**Request for Additional Information No. 167, Supplement 1**

**U. S. EPR Standard Design Certification**

**AREVA NP Inc.**

**Docket No. 52-020**

Figure 15.06.05-28-1—Non-LOOP SGTR RCP  $\Delta P$

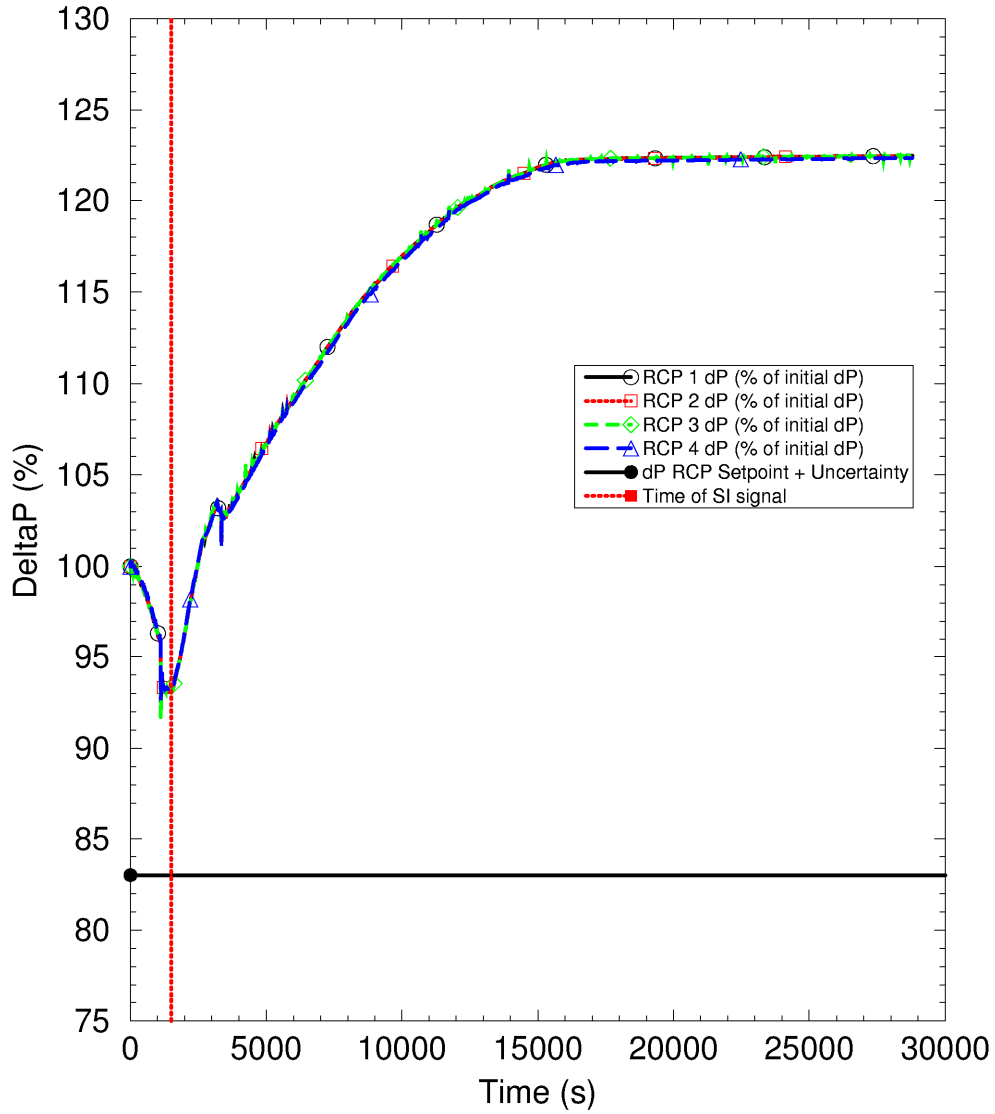
Explain the reactor coolant pump (RCP) trip logic and required operator actions should a small break loss of coolant accident occur. Show that the RCP trip will occur in a timely manner such that heat transfer is maximized while coolant mass loss is minimized. Explain how RCP seals are protected. Show that the RCPs will not be inadvertently tripped during a steam generator tube rupture event. Provide emergency procedure guidelines, intended criteria and proposed ITAAC related to operator actions for RCP trip. This question is asked to satisfy requirement of GDC 35, "Emergency Core Cooling."

Figure 15.06.05-28-1 shows that the RCPs do not inadvertently trip during a SG tube rupture (SGTR) event without LOOP. Throughout the transient, the RCP  $\Delta P$ s are above the maximized setpoint (80 percent + uncertainty = 83 percent). Additionally, the RCP trip requires the presence of the SI signal. At the beginning of the transient the RCP  $\Delta P$  is decreasing; however, even if the setpoint is reached, the RCP trip would not occur because no SI signal is present. The actuation of SI on low pressurizer pressure also automatically initiates a partial cooldown of the RCS. The partial cooldown reduces the SG main steam relief train (MSRT) setpoints at a constant rate. With the reduction of SG pressure, the cold leg temperatures decrease and the densities increase. Because the RCP  $\Delta P$  is highly dependent on liquid density, following the SI signal, the RCP  $\Delta P$ s increase.

**Figure 15.06.05-42-1—Hot Rod Cladding Temperature for the 8.0 inch Break**

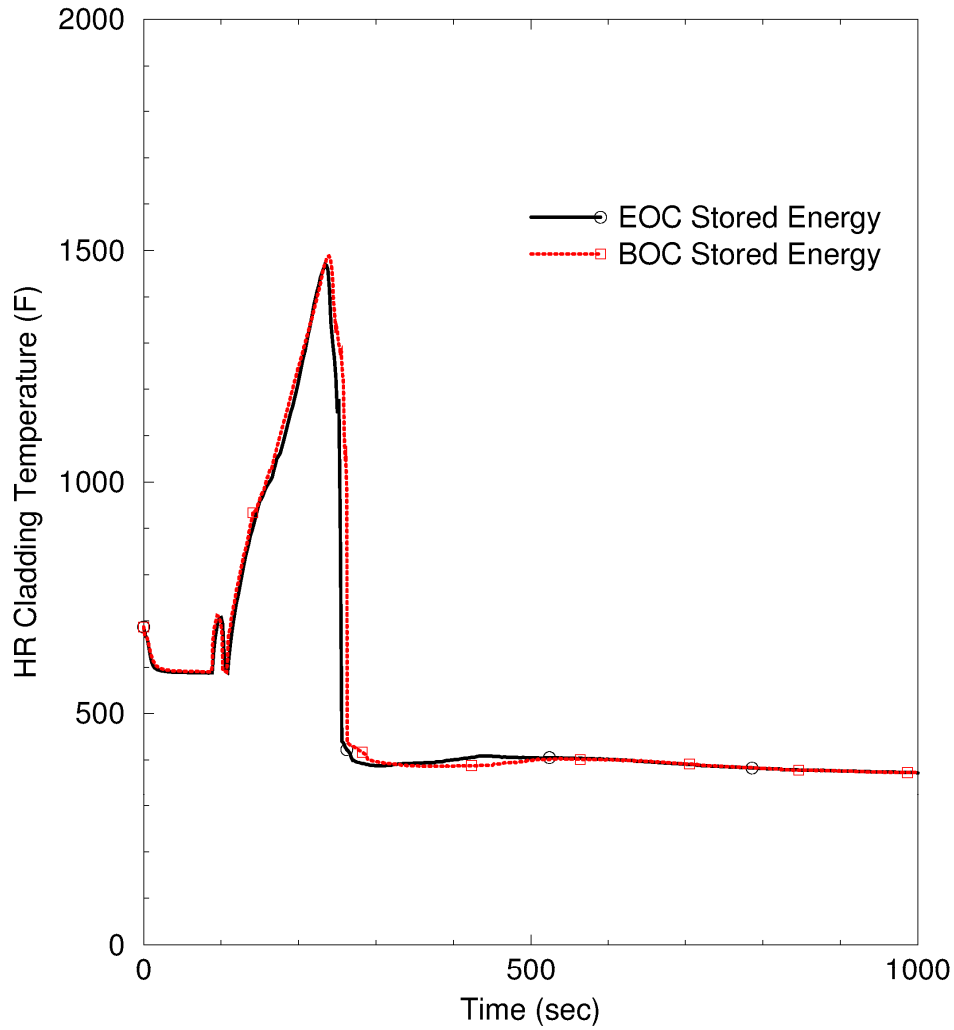
Although it is possible that the initial core stored energy may not significantly contribute to the PCT, it may have an impact on the SBLOCA core heat transfer characteristics when the break size approaches the upper break size limit of the applicable range of the SBLOCA method. Explain the impact of initial core stored energy on the break size upper limit if the hot rod and assembly are under-predicted by 400 and 350 degrees F respectively, and the inner core region and outer core region by 200 and 100 degrees F respectively. In addition, it appears that boron dilution analysis result during the SBLOCA transient is sensitive to scenario progression through the accident. Discuss the impact of any initial core stored energy under prediction on the result of the boron dilution analysis.

Figure 15.06.05-42-1 and Figure 15.06.05-42-3 show a comparison of the hot rod PCT at the two stored energy conditions for the 8.0 inch and the 9.71 inch ID breaks, respectively. Table 15.06.05-42-1 summarizes the results for these two break cases at the two different stored energies. The system response at the two stored energy conditions show agreement for both break sizes: the hot rod PCT shows an increase of less than 20°F when a higher stored energy

condition is assumed, the PCT occurs at the same axial location and approximately the same transient time for both conditions, and the loop seal clearing pattern is consistent between the two conditions. The 20°F change in PCT is insignificant.
